RE: **Volcano Cliffs Subdivision Lot 5, Block 8, Unit 22**  
**5412 Canavio Pl NW**  
**Grading and Drainage Plan**  
**Engineers Stamp Date 5/24/17 (D10D003E5)**

**RE: Lot 5 Block 8, Unit 22 Volcano Cliffs  
6412 Canavio Pl NW  
Grading and Drainage Plan  
Engineers Stamp Date 3/25/15 (D10D00E5)**

**GRADING AND DRAINAGE PLAN**  
**LOT 5, BLOCK 8, UNIT 22, VCS**  
**ADDRESS: 6412 Canavio Pl NW**  
**Lot 5**

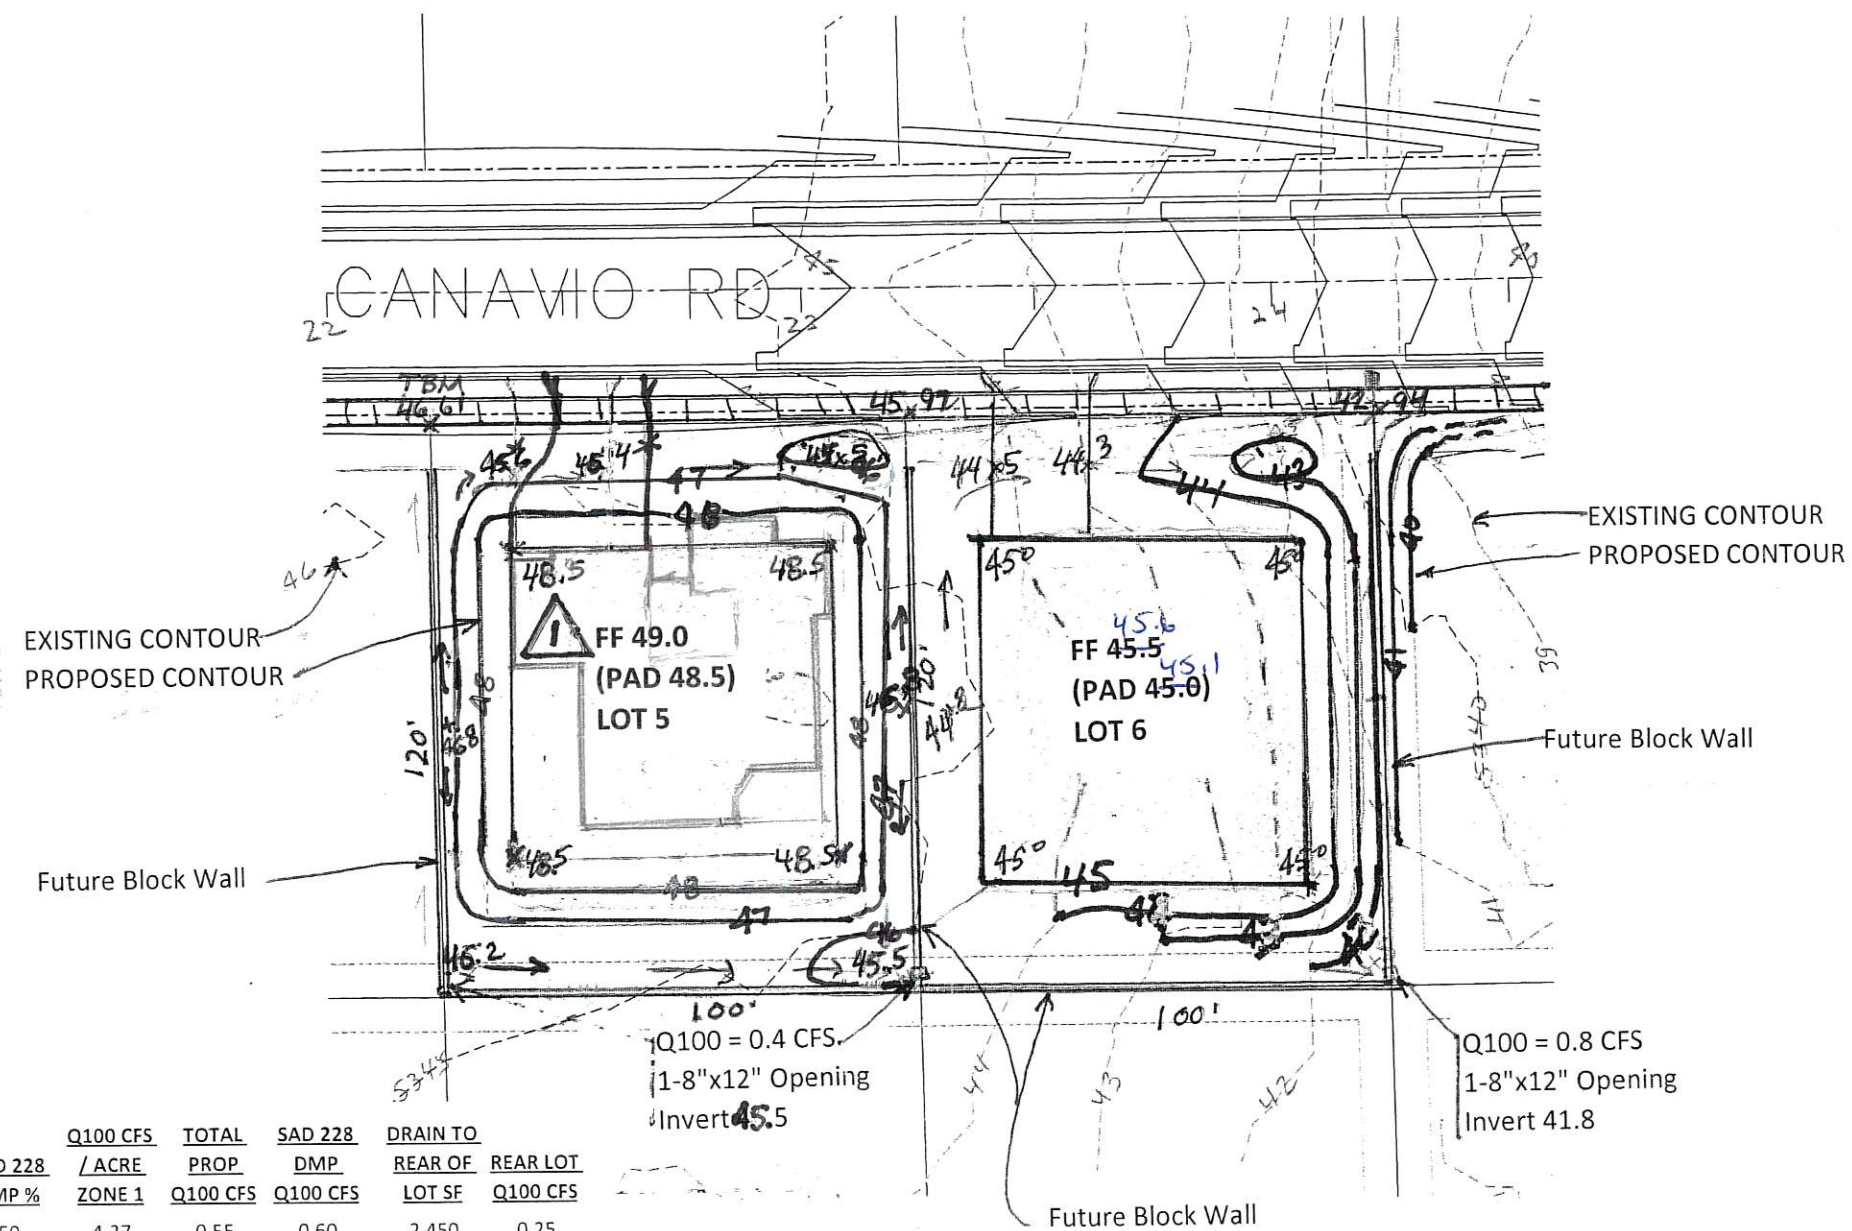
Based upon the information provided in your submittal received 5/24/17, this plan is approved for Grading Permit. Building permit will not be issued until Pad Certification is accepted.

Please attach a copy of this approved plan to the construction sets in the permitting process prior to sign-off by Hydrology. Also, please advise the owner/contractor that a separate wall permit must be obtained and this approved grading plan dated 5/24/17 must be provided with the wall permit application. Also, please advise the contractor/owner that the ponds must stay in place or CO will not be granted.

**A pad certification is required before concrete is poured, either by a letter from you stating that the pad is built according to the plan submitted or by an as-built with elevations plotted.**

Revised to raise FF due to rock
